In the Matter of)
) Docket Nos. 50-445 and
TEXAS UTILITIES ELECTRIC) 50-446
COMPANY, ET AL.)
) (Application for
(Comanche Peak Steam Electric) Operating Licenses)
Station, Units 1 and 2))

AFFIDAVIT OF JOHN C. FINNERAN, JR. IN SUPPORT
OF APPLICANTS' REPLY TO CASE'S ANSWER TO
APPLICANTS' MOTION FOR SUMMARY DISPOSITION
REGARDING LOCAL DISPLACEMENTS AND STRESSES

BY J. SHIN DATE 9/19/84CHKD. BY Atch DATE 9/19/84CLIENT TUGCPROJECT COMANCHE PEAK S.E.SSUBJECT 3-D OPEN END BOX BEAMSHEET 1 OF
OFS NO 2970.002 DEPT. NO 462

SHEET 11 OF 11

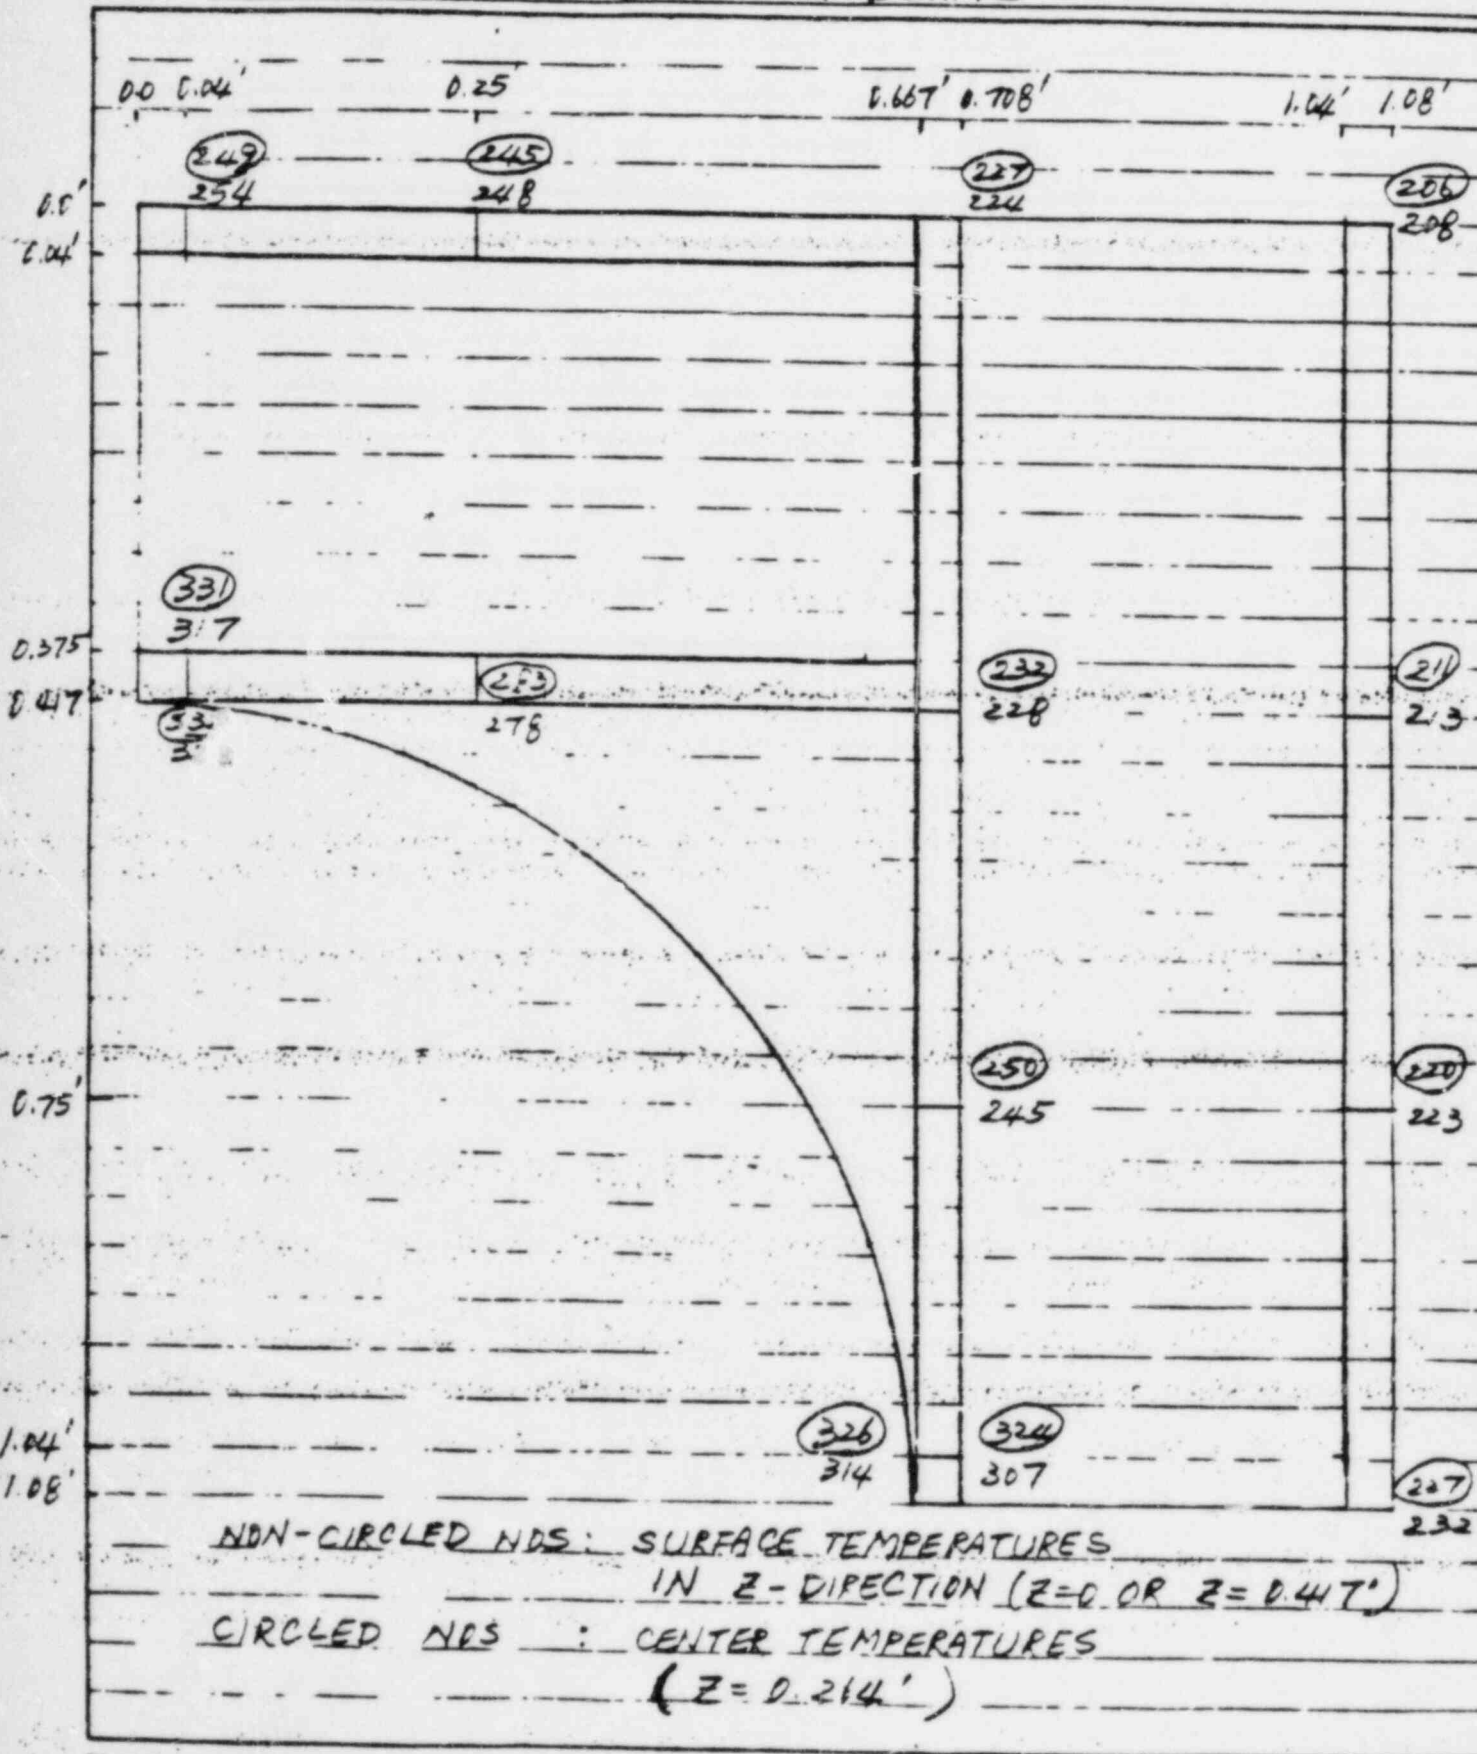
A. CASE contends that the temperature gradient in the tube steel will vary along the tube from that existing through the tube at the point of contact of the frame and the pipe (Affidavit at 4). However, CASE does not point to any particular effect it believes this varying temperature gradient will have on Applicants' analysis. Consequently, it is not possible to respond directly to CASE's argument. It should be noted, nonetheless, that Applicants' finite

difference analysis mentioned above demonstrated that the temperature gradients along the tube are, in fact (as originally assumed) nearly linear across the frame and along the length of the tube away from the point of contact between the frame and the pipe (Attachment A; sh. 11 of 11). Thus, although the gradients do vary, Applicants' assumption of linearity for taking an average temperature of the tube was reasonable and, in fact, conservative given the conclusion from the finite element analysis that the lowest temperature in the frame (206°F) is actually higher than the average temperature (203°F) originally assumed. Thus, the expansion of the frame will actually be greater than initially estimated.
